# ***Interactive comment on “Hydraulic fracturing in thick shale basins: problems in identifying faults in the Bowland and Weald Basins, UK” by David K. Smythe***

**R. Westaway**

Received and published: 4 March 2016

**Fig. 1.** Please refer to the main document for this Figure caption.

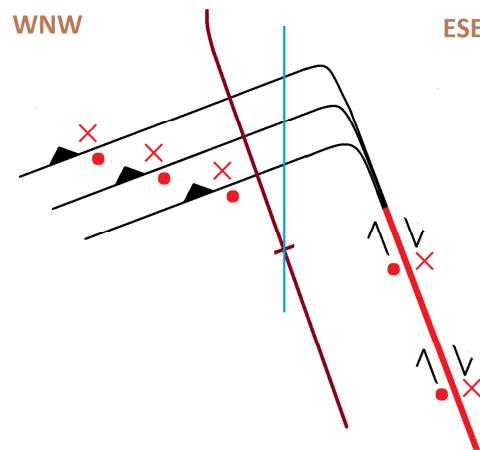
Fourth, Clarke (2016) criticizes the Smythe (2016) interpretation that the 2011 seismogenic fault cut across the Preese Hall-1 borehole, accounting for the observed wellbore deformation. However, as previously discussed (Westaway, 2016b), this struck me as pretty much the most useful aspect of the Smythe (2016) contribution, since it confirms – in general terms – my own stated view; the principal problem with it being that it was based on an incorrect geometry of the fault, having been confounded by some of the mistakes in the original Clarke et al. (2014) publication. From de Pater and Baisch (2011) and Harper (2011), the wellbore deformation was concentrated

between depths of  $\sim$ 8500 and  $\sim$ 8650 feet (MD) ( $\sim$ 2591-2637 m MD), equivalent to  $\sim$ 2540-2590 m (TVD). This is close to what was previously interpreted as the top of the Hodder Mudstone Formation, just below the base of the Pendleside Limestone Formation, and is now regarded as near the top of the Lower Bowland Shale, not far below the aforementioned Emstites leion marine band. De Pater and Baisch (2011) reported that the bedding in this vicinity dips WNW at  $\sim$ 30° and the wellbore deformation involved strike-parallel shearing, at an azimuth of  $\sim$ N30°E, but due to the ambiguity inherent in such measurements (using a multi-fingered caliper tool) had no means of resolving whether the sense of shear was top-to-the-NNE or top-to-the-SSW. This part of the stratigraphic succession consists of interbedded mudstones and limestones; the correlation between the gamma ray log and the wellbore deformation indicates that slip occurred on bedding planes at changes in lithology (cf. de Pater and Baisch, 2011; Harper, 2011). Clarke (2016) is correct to note this interpretation of bedding plane slip, but it does not mean that the slip was not caused by the induced seismicity; the Dusseault et al. (2001) reference cited by Clarke (2016) indeed includes examples of bedding plane slip caused by seismicity. Figure 1 indicates schematically in cross-section how this bedding plane slip might have linked to the coseismic faulting; the inferred geometry resembles a conventional ‘horsetail splay’ (e.g., Sylvester, 1988) or ‘contractional imbricate fan’ (e.g., Woodcock and Fischer, 1986) fault termination. From consideration of the magnitude (2.3) and, thus, seismic moment, of the largest Preese Hall induced earthquake, a coseismic displacement of  $\sim$ 10 mm can be estimated (cf. Westaway and Younger, 2014); it is envisaged that, beyond the up-dip limit of this fault, this shear displacement would have been partitioned across the various planes of weakness within the deformed zone. One reason why this wellbore deformation has not hitherto been associated with the induced seismicity was that Clarke et al. (2014) located the seismicity so far from the wellbore. This argument was superseded by the realisation of the mistakes in their paper and the resulting adjustment of the position of the seismogenic fault much closer to the wellbore (Westaway, 2016a). Another reason has been because de Pater and Baisch (2011) were unable to identify a clear con-

ceptual link between the seismogenic fault and the wellbore deformation. Since such a link is now evident (Fig. 1), this issue warrants further attention. In the meantime, I note in passing that Clarke's (2016) comment that 'all of the evidence collected to date supports the observation that the wellbore was within 300 m of a fault but does not intersect it' is not in fact correct. On the contrary, it would appear that the wellbore intersected the 'horsetail splay' or 'contractional imbricate fan' at the up-dip termination of this fault (Fig. 1); by most definitions this is regarded as part of the fault.
